## ADDENDUM #1

TO: REGISTERED VENDORS  
FROM: Mary-Ann Ervin – Purchasing Agent  
SUBJECT: Public Parking Lot Signage  
DATE: April 26, 2016

**DRAWING**

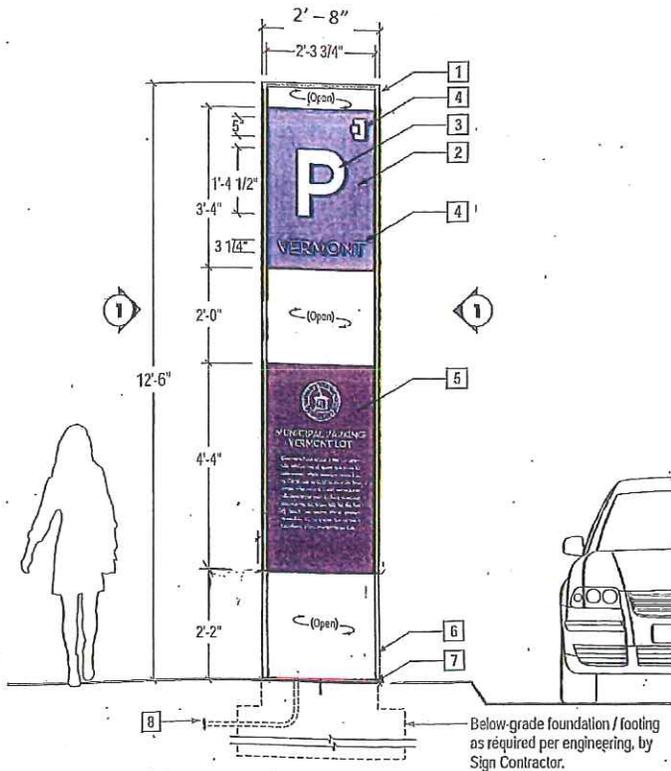
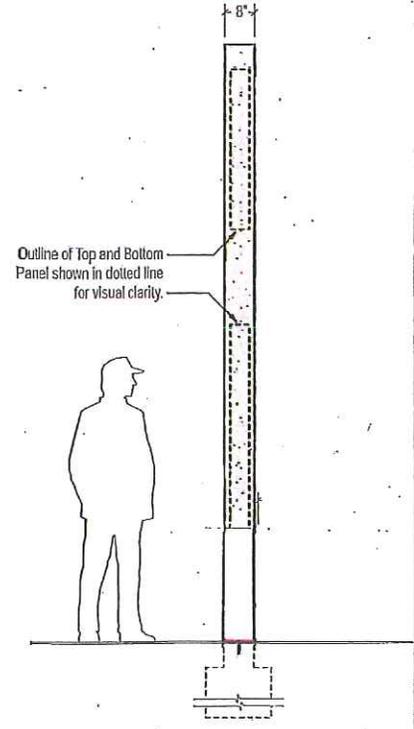
Please note ADDENDUM # 1 includes changes to the Specifications portion of the original bid, as well as a revised DRAWING.

# PARKING SIGN FOUNDATION

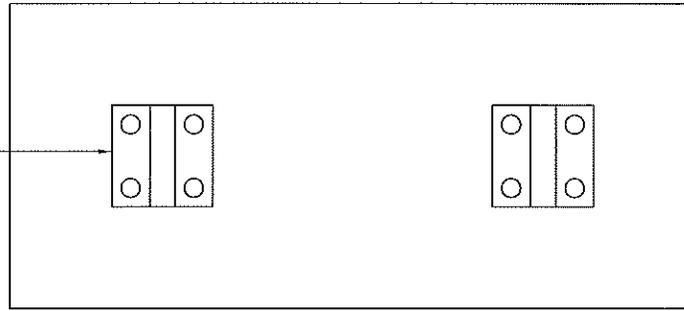
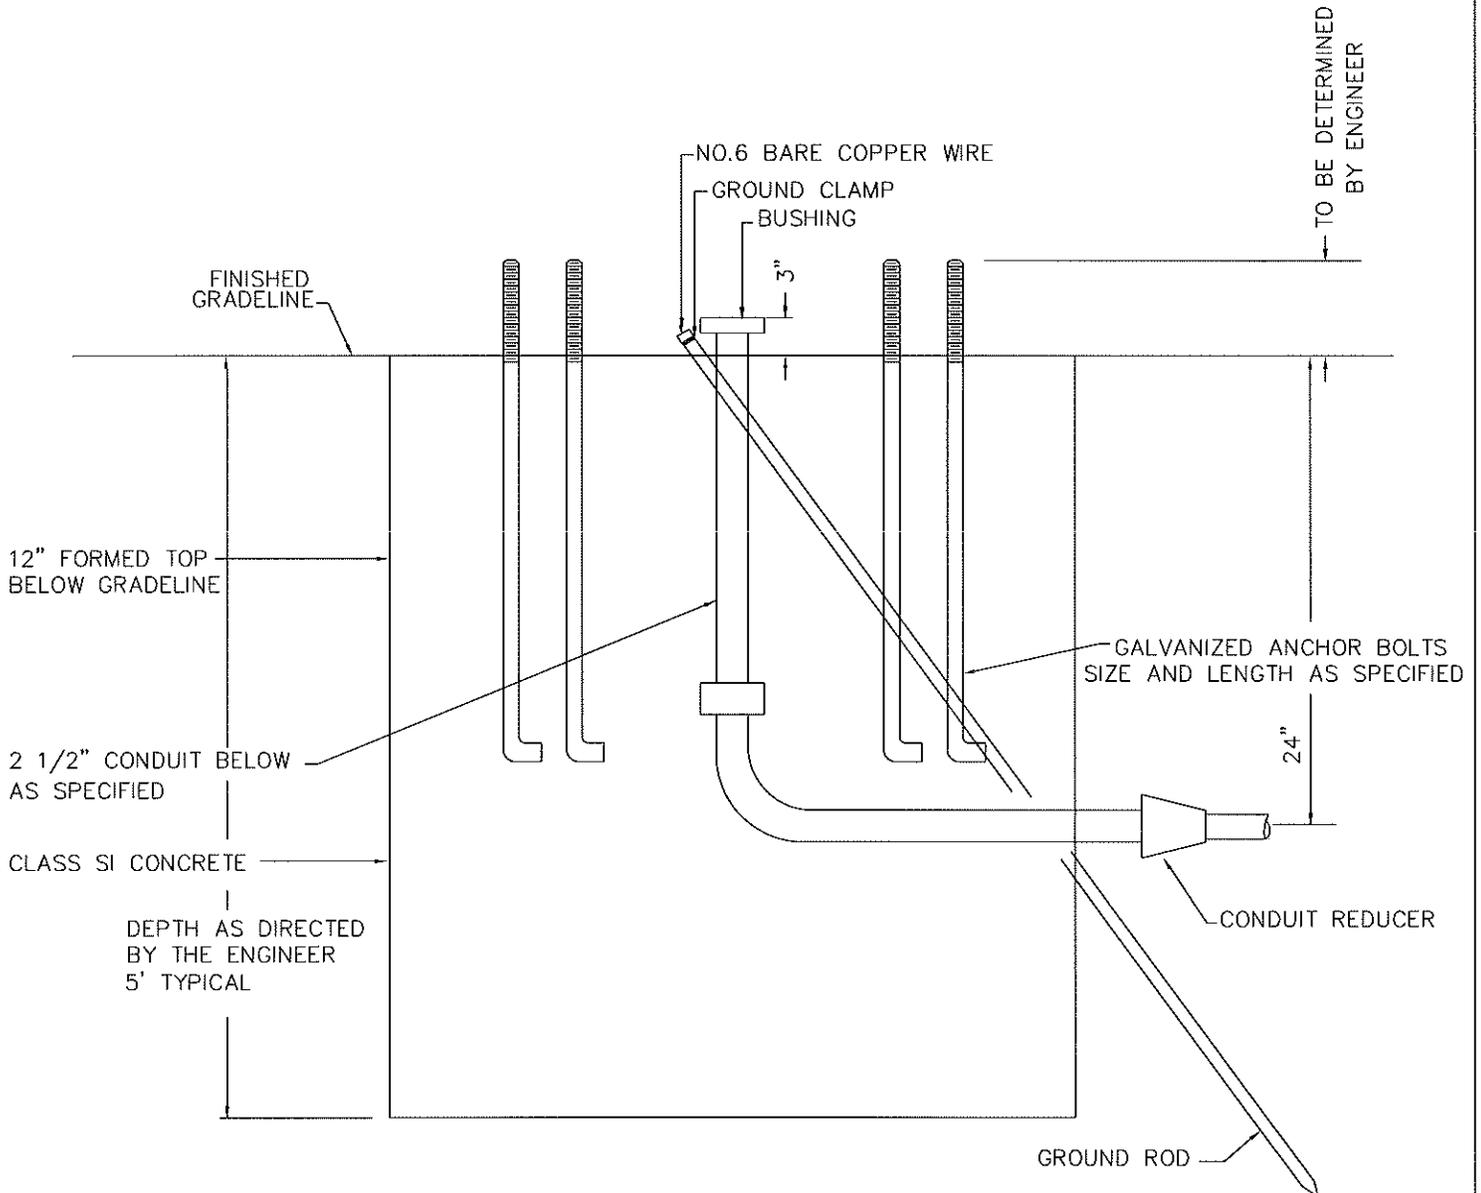
Also included with this ADDENDUM #1 is an EXAMPLE of a Parking Sign Foundation.
